## Product Change Notice (PCN)

PCN Number: **PCN-0456246R-01**

Product(s) Affected: **SJ1-2503A**

PREVIOUS CUI DEVICES DETAIL / IMAGE	NEW CUI DEVICES DETAIL / IMAGE

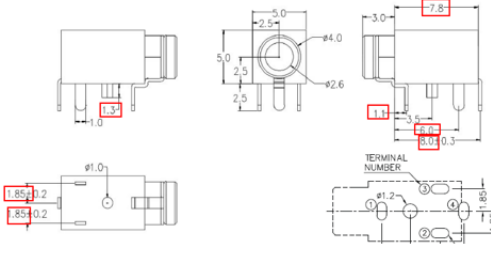
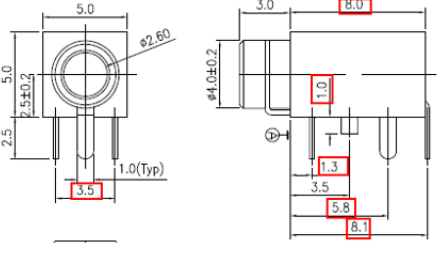
Description of Change: **New Factory Location. Product re-engineered for improved manufacturability and production yield. See image below for reference and check CUI Devices website for updated drawing. Cosmetic differences may be visible and not affect the form fit and function of the product.**

PREVIOUS CUI DEVICES DETAIL / IMAGE			NEW CUI DEVICES DETAIL / IMAGE		
DESCRIPTION	MATERIAL	PLATING/COLOR	DESCRIPTION	MATERIAL	PLATING/COLOR
terminal 1	brass	silver	terminal 1	phosphor bronze t=0.30	tin over nickel
terminal 2	copper alloy	silver	terminal 2	phosphor bronze t=0.30	tin over nickel
terminal 3	copper alloy	silver	terminal 3	phosphor bronze t=0.30	tin over nickel
terminal 4	copper alloy	silver	terminal 4	brass t=0.30	tin over nickel
bushing	brass	nickel	bushing	copper alloy	nickel
housing	PBT (UL94V-0)	black	housing	PAB (UL94V-0)	black
